# INDIANA DEPARTMENT OF TRANSPORTATION

RE: Dual Review Project: I-65/I-70 North Split Interchange Reconstruction Project  
(Designation (Des.) Numbers (Nos.) 1592385 & 1600808)  
IDNR DHPA No. 21534  
Section 106 Update Memo #10

**Section 106 Update Memo #10**

# **Attachment B**

# Screen Plantings without Berm

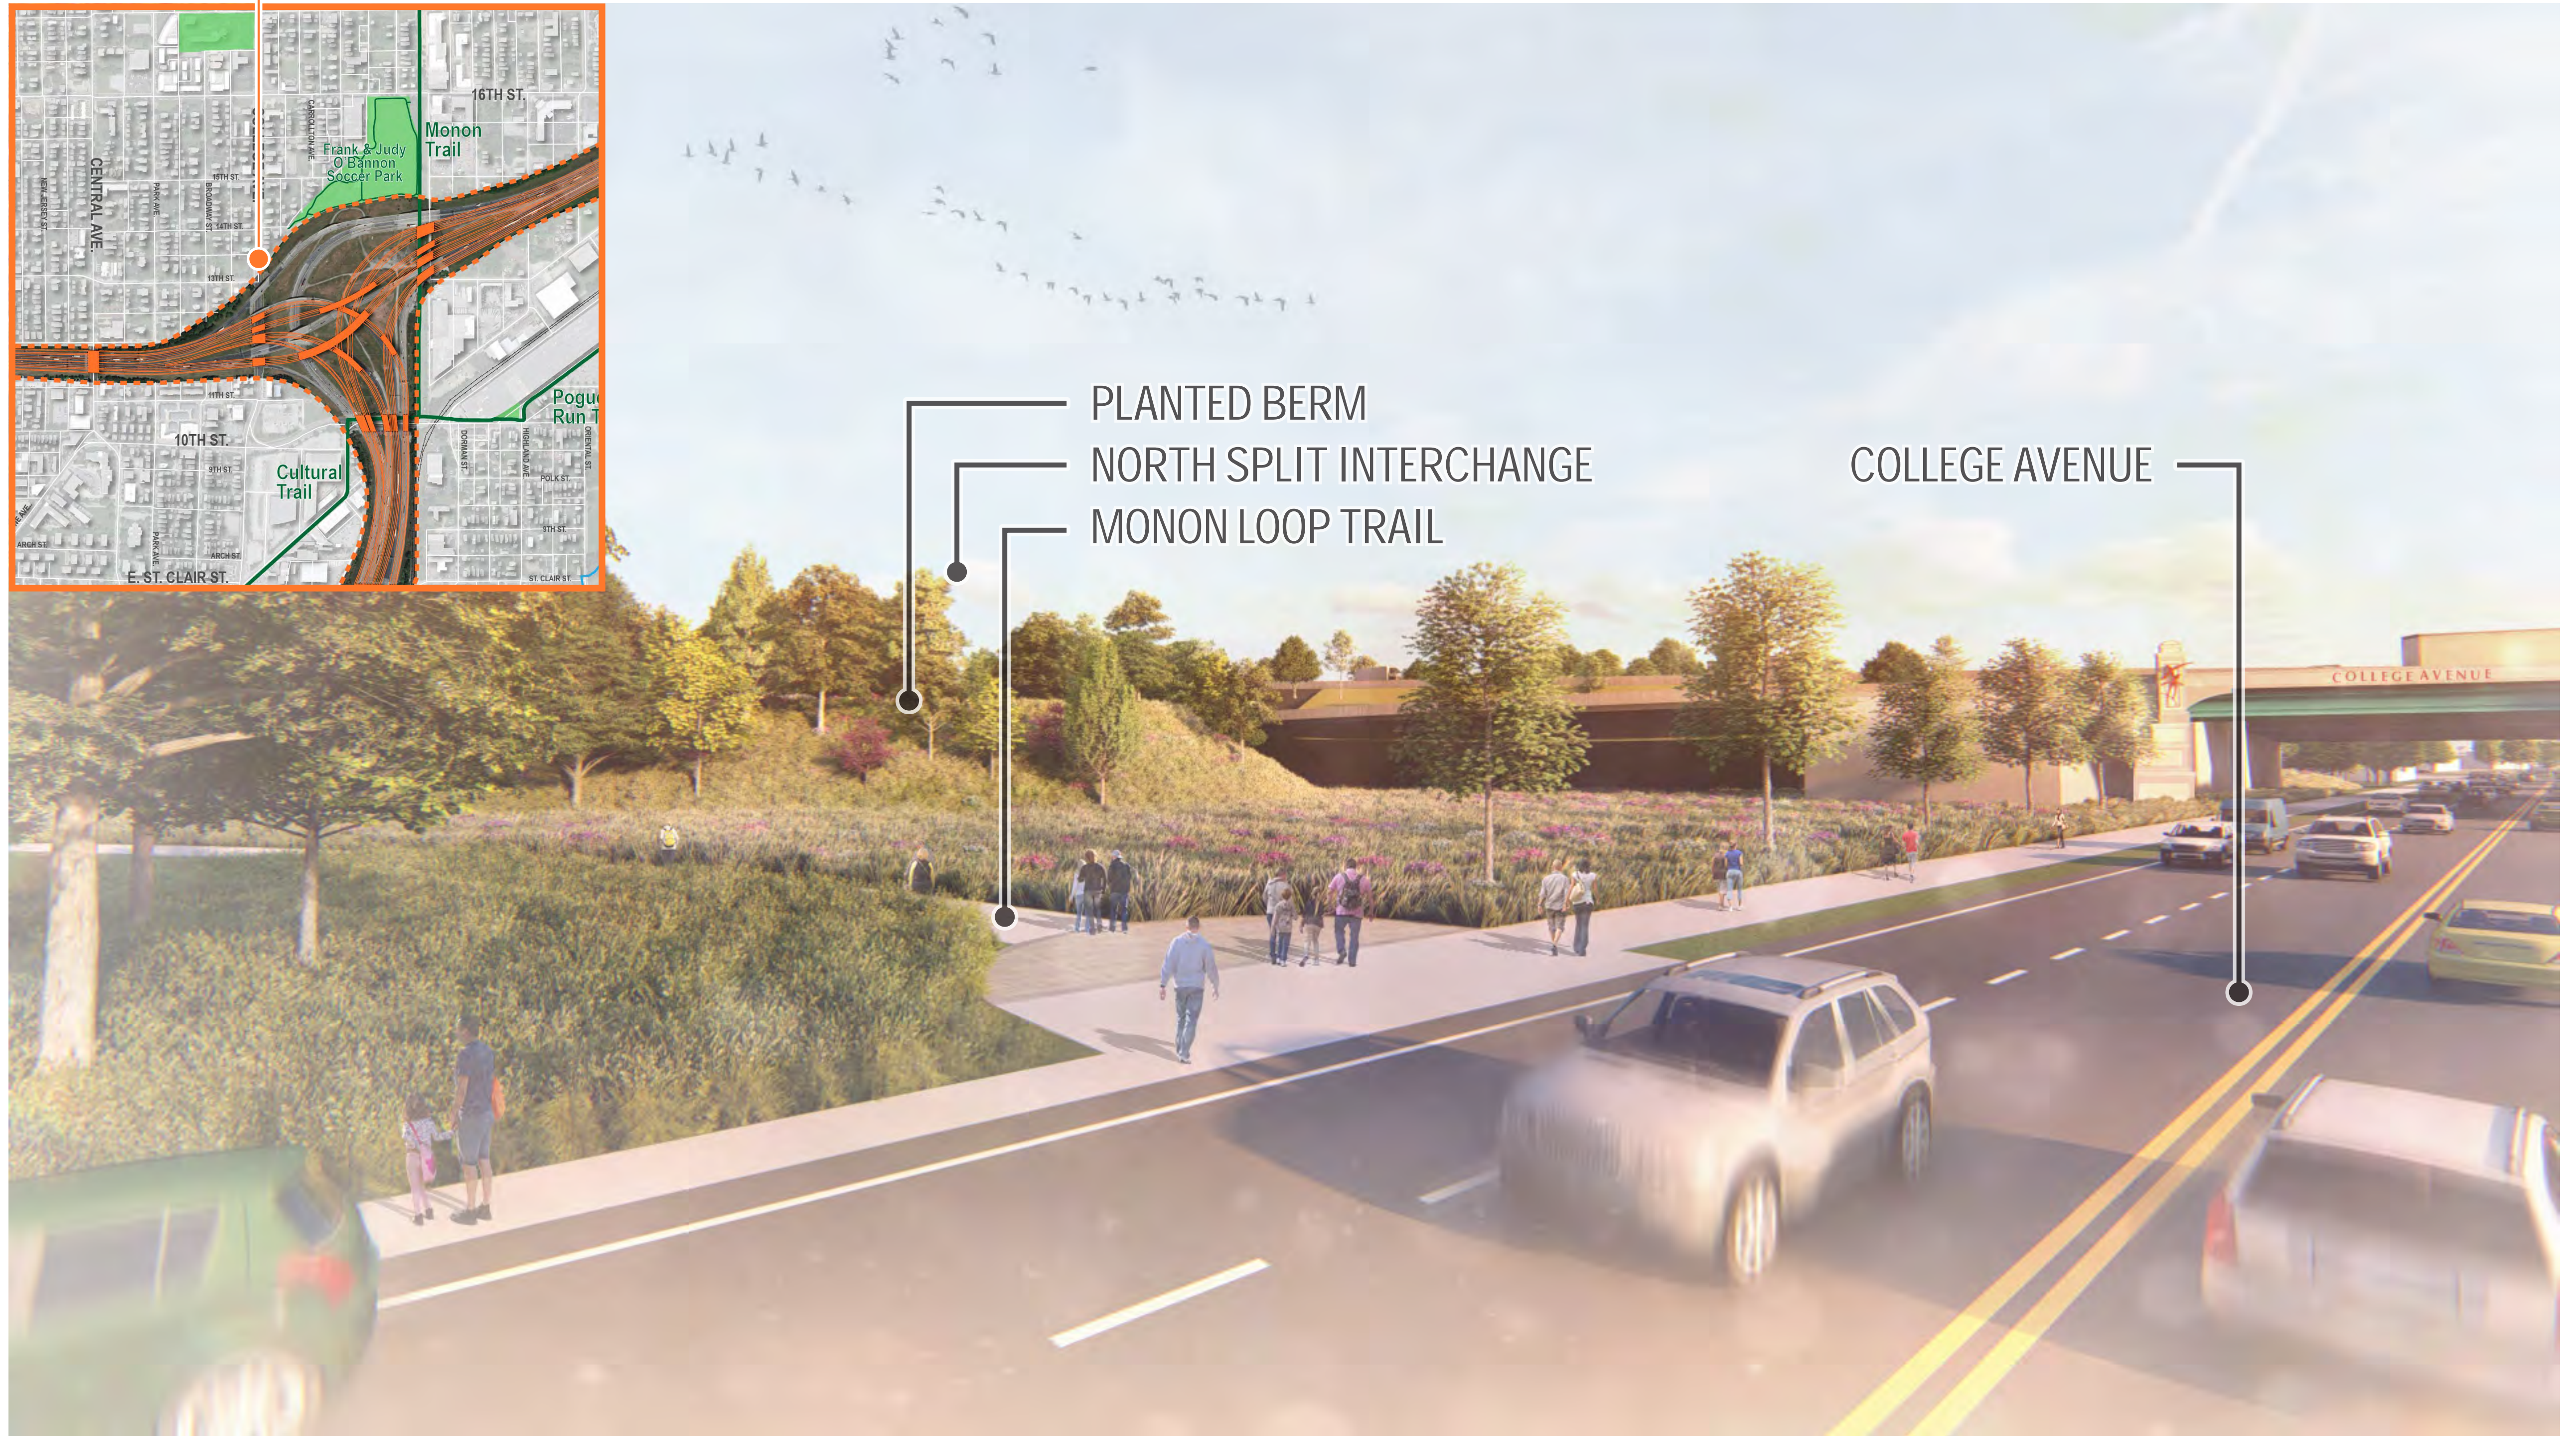
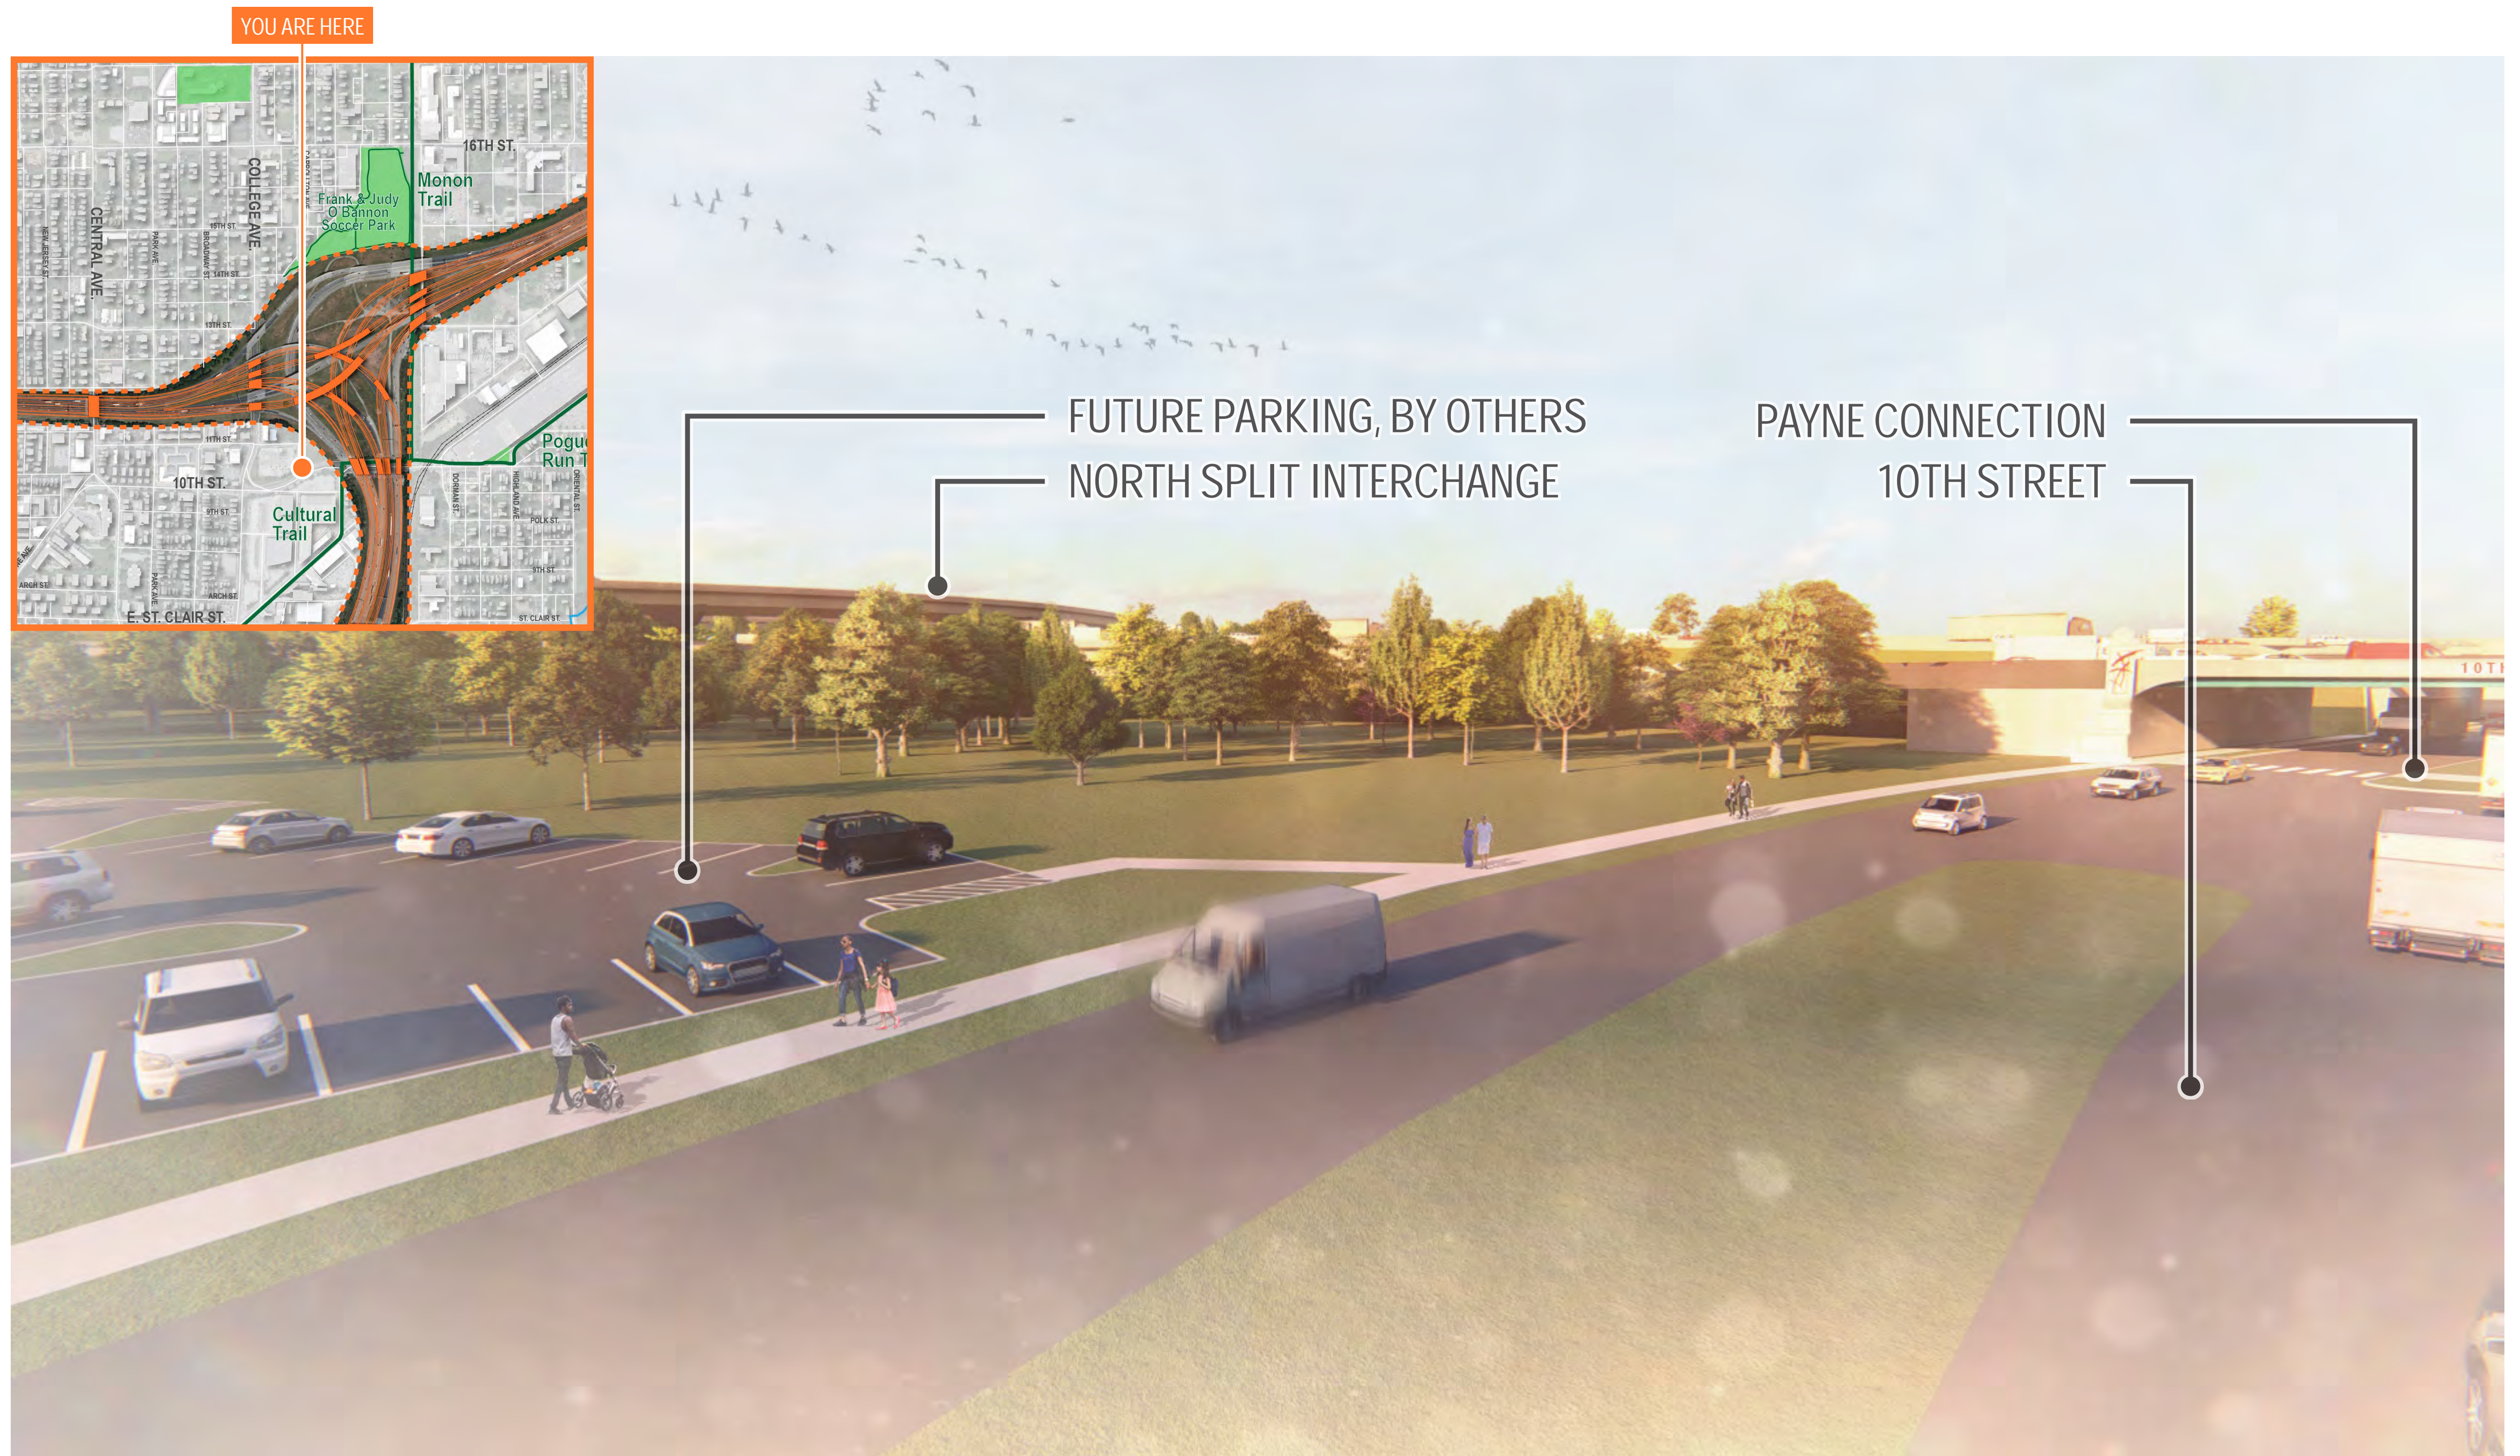
We are requesting input from consulting parties, particularly the Old Northside and Chatham-Arch Historic Districts, regarding whether or not they would prefer to keep the planted earthen berms as visual shielding from the interchange ramps or if they would prefer to have them removed. Trees will be planted in the interchange area with or without the berms.

<p>While we believe that retention of some portions of the earthen berm might provide a level of visual screening of the highway from adjacent neighborhoods, we also appreciate the views of other consulting parties which may desire a flatter, more open landscape between districts and the highway. Either way, we think that the inclusion of tree planting, with or without retention of earthen berms, would be a desirable and appropriate measure to improve the appearance of the project area from adjacent neighborhoods.</p>	<p>INDOT has developed renderings of the interchange with and without the earthen berms (see Attachment B). The berms could be sculpted and trees planted to make them appear more natural. Additional information regarding the possible berms is included in Section 106 Update Memo #10 and additional input from consulting parties is being requested before a final decision is made about the berms.</p>

INDOT and FHWA offer the following clarification regarding potential earthen berm mitigation. The two berms proposed to remain in place are located in the northwest quadrant of the interchange, extending from approximately 14<sup>th</sup> Street to College Avenue, and in the southwest quadrant of the interchange, extending from College Avenue to 10<sup>th</sup> Street. The berms would be sculpted into a more natural shape and planted with trees such that they do not appear as abandoned “roadbeds” (see Attachment B). The final shape of the berms would be included in the draft landscape and side slope plan provided to consulting parties for comment. The intent of retaining the berms is to provide visual shielding from the interchange ramps for the Old Northside and Chatham-Arch neighborhoods. They would also provide some noise reduction for nearby properties. All other remnants of previous “roadbed” use would be removed from areas that will no longer serve such a use, including those adjacent to the O’Bannon Soccer Park. Retaining these berms would not preclude land use changes in this area in the future.

The traffic noise analysis and results in the previously published Draft Traffic Noise Technical Report (<https://northsplit.com/wp-content/uploads/2019/10/FINAL-North-Split-Draft-Noise-Report.pdf>) included the earthen berm across the northern portion of the interchange (including the northeastern area near O’Bannon Soccer Park). This berm did provide some noise reduction. A traffic noise model was created that removed the earthen berm to determine what, if any, impacts would occur as a result of the removal of the berm. The model did not predict any additional noise impacts (over 66 decibels (dB(A)) per the INDOT Traffic Noise Analysis Procedure) for receptors near the earthen berm if it is removed. Noise levels without the berm ranged from 1.9 dB(A) lower to 0.2 dB(A) higher than the existing level. These changes are not likely to be perceptible. However, the reduction of noise is greater if the berm is left in place. With the berm in place, predicted noise values range from 57.6 to 65.1 dB(A). Without the berm in place, predicted noise values range from 60.1 to 65.8 dB(A). Predicted noise levels with the berm range from 0.7 to 4.3 dB(A) less than without the berm (see Attachment C). A difference of 4.3 dB(A) is likely perceptible. The berm in the southwest quadrant of the interchange was not originally included in the traffic noise analysis.
